Reference: 24.053r06v02

Re: 30-34 Padstow Parade & 10 Faraday Road, Padstow – Proposed Mixed-use Development (SSD-71454709-Mod-1)
Response to Canterbury Bankstown City Council Submission to the State Significant Development Application, 30-34 Padstow Pde and 10 Faraday Rd, Padstow

Swept Path Analysis
Ground Floor
Passing Opportunity for Egressing vehicle
B99 Design Vehicle Passing a B85 Design Vehicle

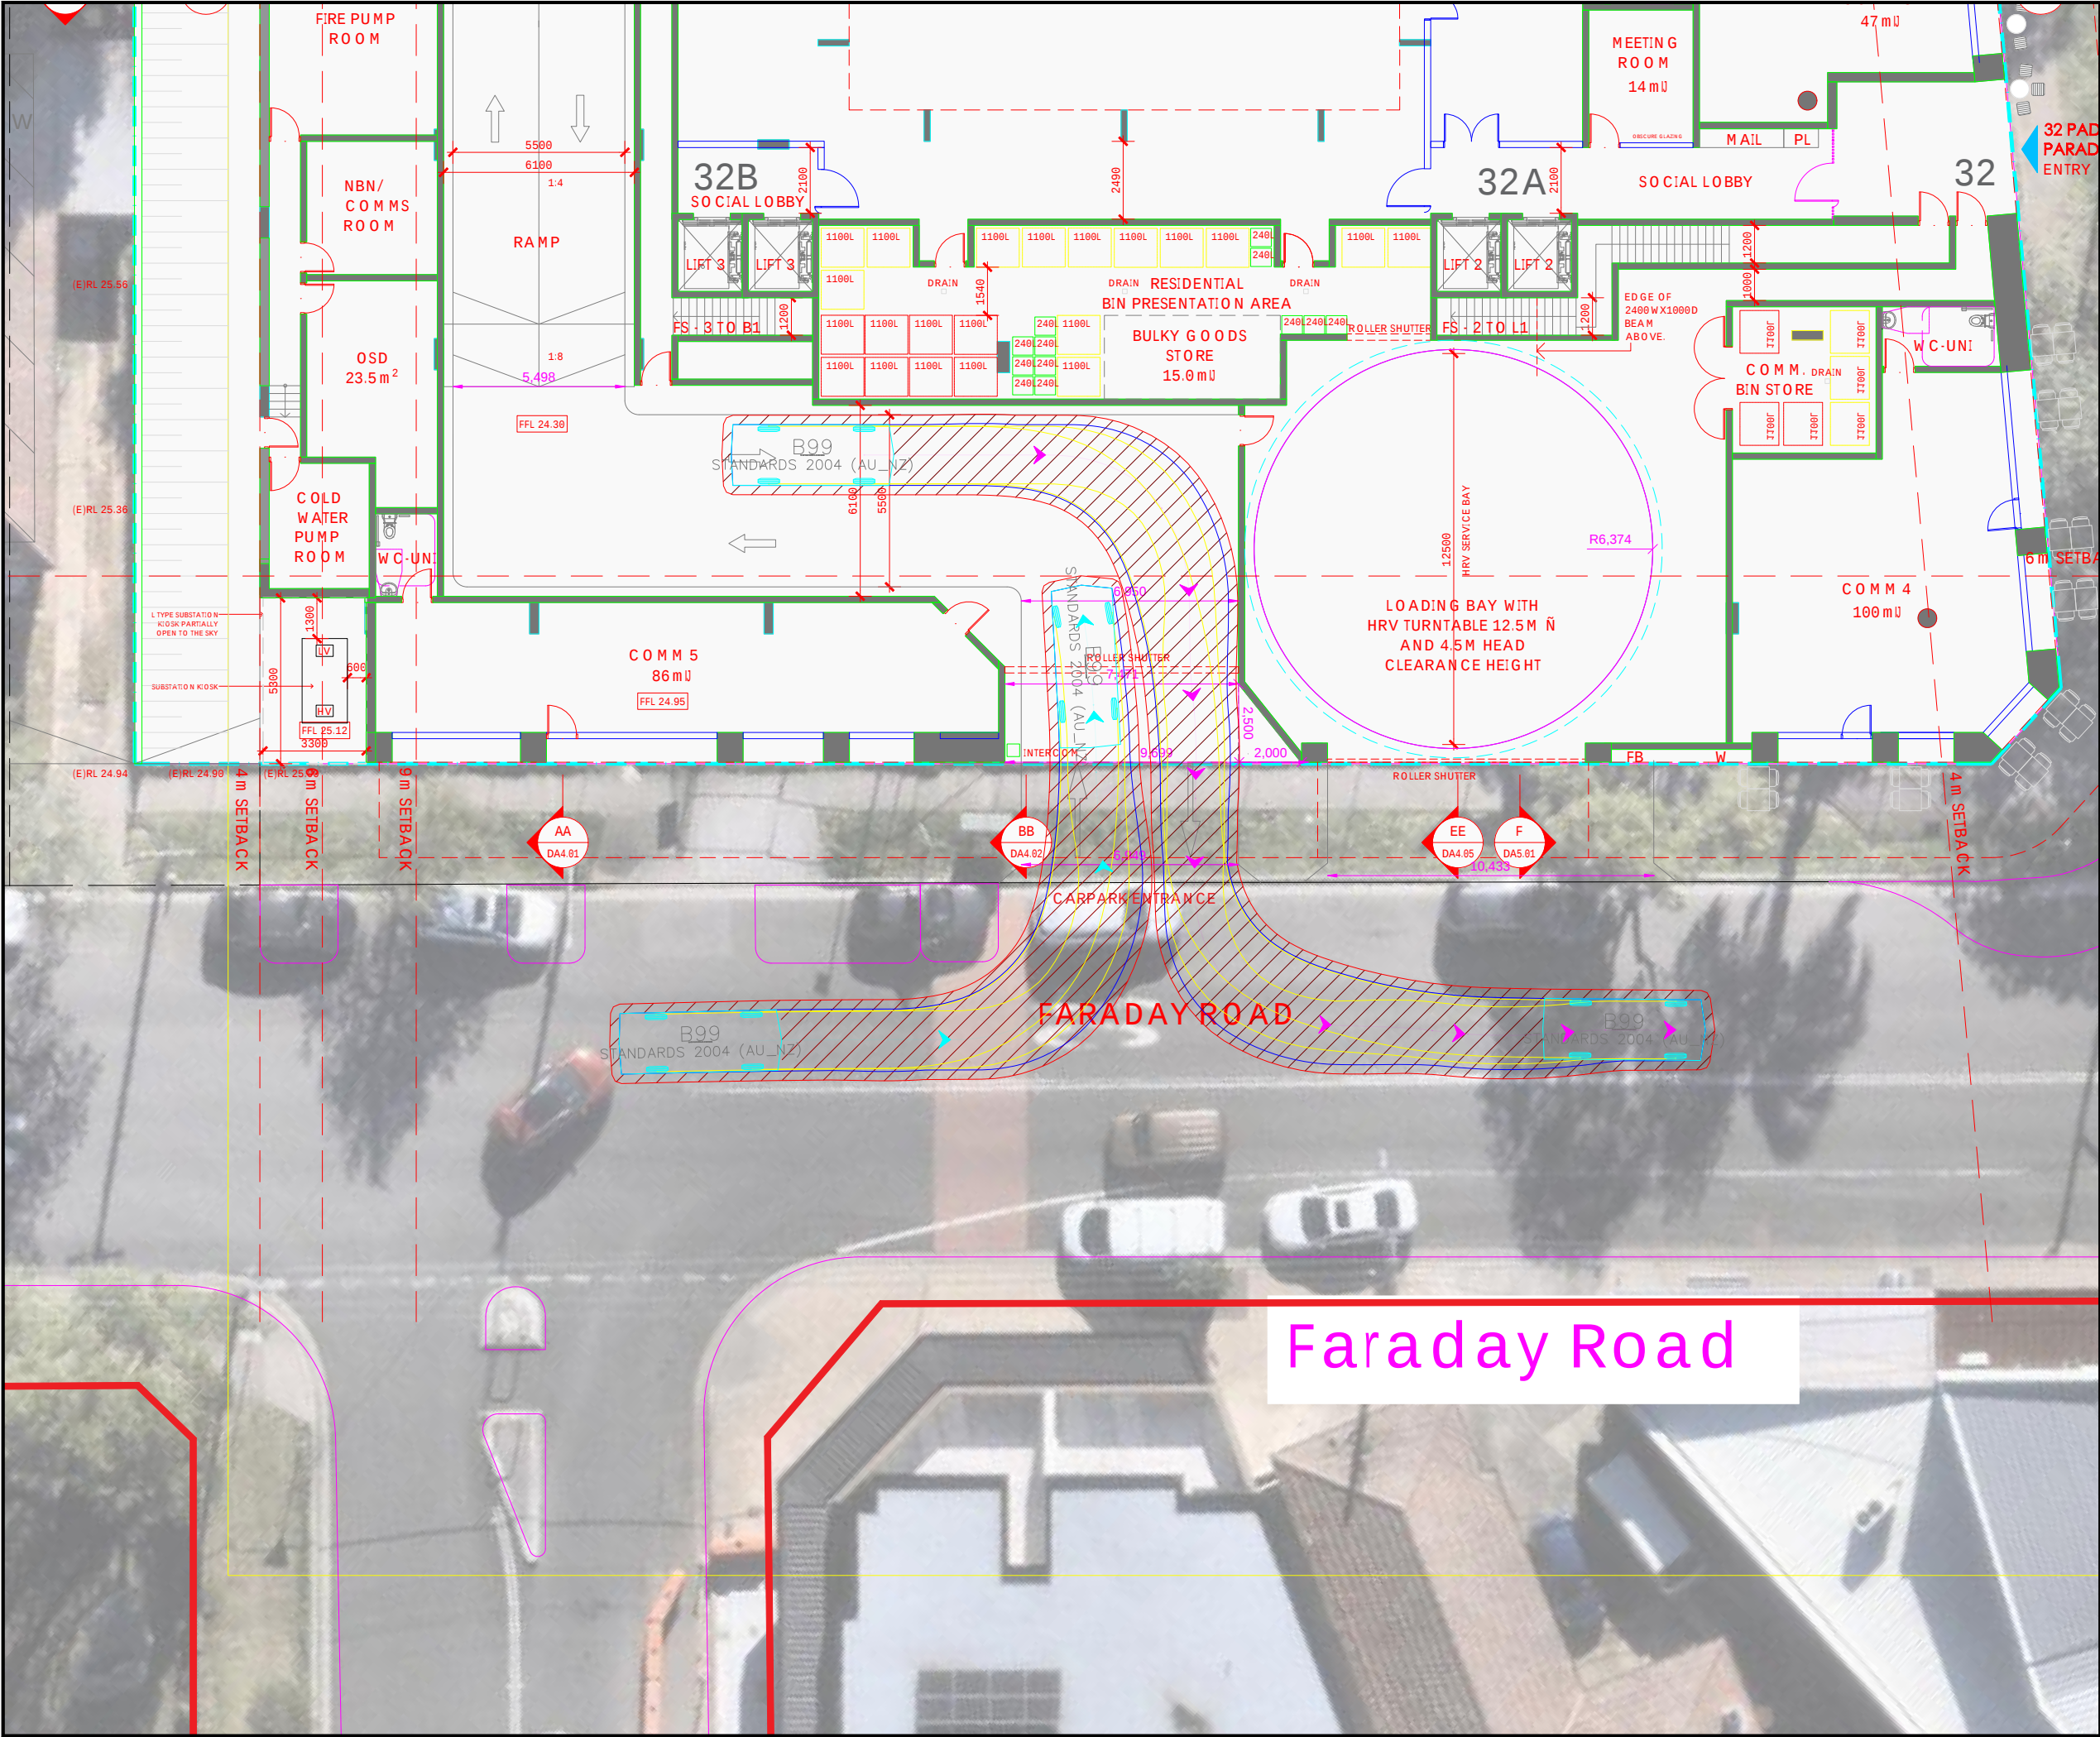
- *"B99 vehicles will not be able to access the basement ramp from the proposed VFC without utilising the entire circulation roadway width, as opposed to staying within designated lanes within the circulation roadway. This fails to comply with AS2890.1 regarding provision of passing opportunities for B85 and B99 vehicles simultaneously."*
- *"Although the circulation roadway has been geometrically designed in accordance with AS2890.1 for two-way traffic flow, our swept path analysis suggests that it can only function as a one-way circulation roadway."*
- *"For reference, a similar swept path was conducted for the originally approved layout which presents a much different scenario with the B99 vehicle being able to access the basement ramp using the allocated lanes."*

- *"The proposed tree planting near the proposed carpark VFC shall be removed to allow for better manoeuvrability of B99 vehicles into the VFC without encroaching onto the other side of the VFC for approach vehicles."*

Reference should be made to the swept path analysis presented in **Attachment 1** showing that adequate passing opportunities have been provided within the property boundary at the access driveway and at the top of the internal ramp. This arrangement will allow drivers to sight passing traffic and to pass within the circulation roadway as demonstrated. Furthermore, the internal circulation roadways have been designed with a minimum width of 6.1 metres measured wall to wall and 5.1 metres measured kerb to kerb which is sufficient to accommodate two-way traffic flow in accordance with Clause 2.5.2 of AS2890.1 (2004).

Reference should be made to the swept path analysis presented in **Attachment 1** showing a B99 turning into the vehicular driveway from Faraday Road with sufficient clearance provided to the proposed tree planting.
